1.0 INTRODUCTION

Attached are the agency and public comments, response to those comments, and the Initial Study Addenda for the Draft Initial Study/Mitigated Negative Declaration for the *Temescal Canyon Road Bridge and Road Realignment Project*, dated March 8, 2018.

The *Temescal Canyon Road Bridge and Road Realignment Project* Initial Study/Mitigated Negative Declaration (IS/MND) (State Clearinghouse No. 2018031021) was circulated to the public and public agencies for a 30-day public review from March 9, 2018 through April 9, 2018. The California Department of Fish and Wildlife requested more time to comment on the Initial Study and was given until April 12, 2018 to provide the City comments. The comments received regarding the project and the responses to comments are included in this document. Six comment letters were received as follows:

Figure 1: Hjulstrom's Diagram

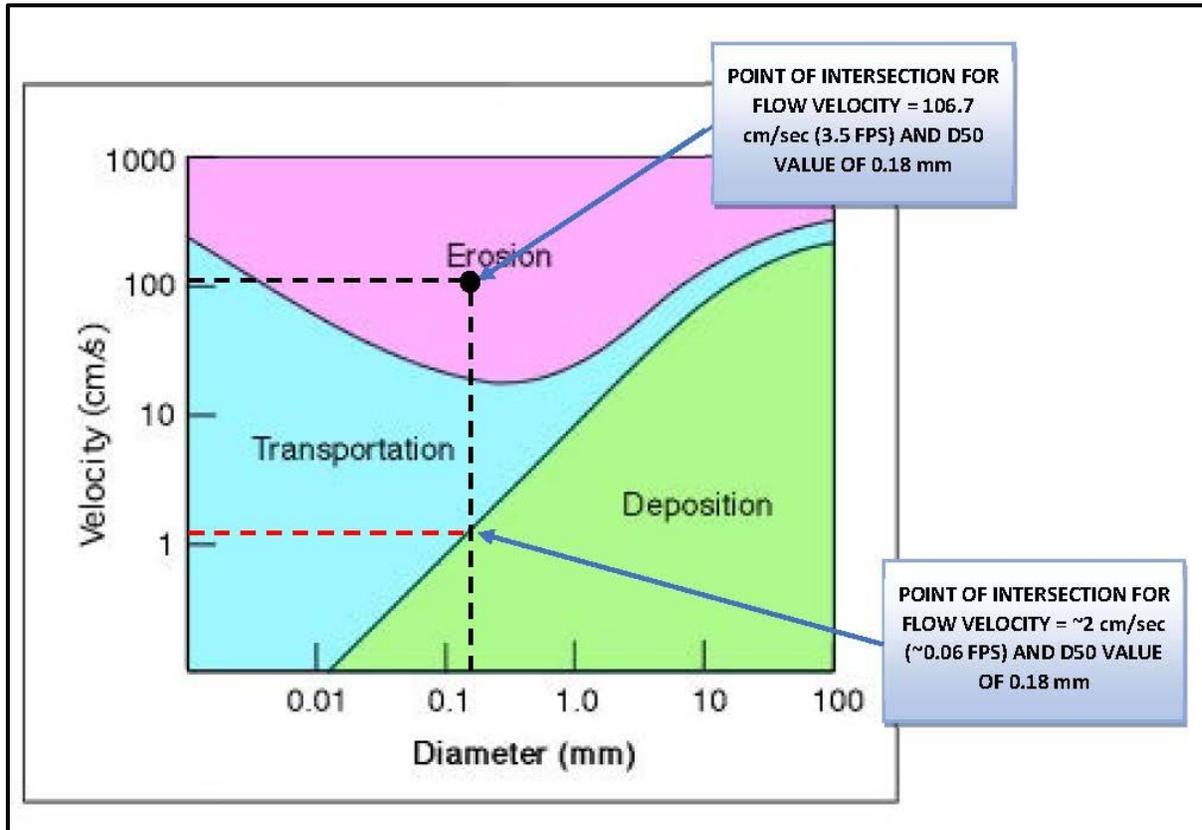
Based on the information provided in the preliminary Geotechnical Report, the Department is concerned that the current bridge design may affect existing stream conditions, including, but not limited to scour/erosion of the stream's banks and channel, perching groundwater, and dewatering adjacent conservation lands. The preliminary Geotechnical Report included with the IS/MND states that "permanent stabilized groundwater may be present at or within a few feet of the Temescal Wash channel bed and potential for perched groundwater at higher elevations near the creek, and during and following floods, is considered high," while "it is proposed to grade the channel with a soft bottom and a central low-flow trapezoidal channel, and to extend the abutment slope paving and pier foundation cut-off level below expected scour depth to about El. 1192 feet, or roughly 10 feet below existing grade."

- According to the preliminary soils report, the soil type in the project area can be classified as Silty Sand and Clayey Sand with approximate D50 values of 0.18 mm and 0.15 mm, respectively. As mentioned previously, the 100-year flow velocity at the upstream face of the proposed bridge is 3.5 FPS. Per the Hjulstrom's diagram (see Figure 1) and based on a flow velocity of 3.5 FPS (or 106.7 cm/sec) and D50 value of 0.18 mm, the soil in the project area is expected to be in the "erosion" section of the diagram, which means that movement of sediment is expected to occur, for soils with a D50 value of 25 mm or less (clay, silt and very fine sand to less than coarse sand). In order for the soils to drop off or settle in the bridge area, the flow velocity needs to be about 0.06 FPS (or 2 cm/sec) or lower, which is not

expected to occur even during the more frequent storm event (i.e. less than the 100-year event such as the 2, 5 or 10-year events). Please note that the computed flow velocity of 3.5 FPS was derived based on high roughness coefficients (Manning's N-values) of 0.07 for the main channel and 0.055 for the floodplain area to reflect the proposed vegetation plan within the conservation easement.
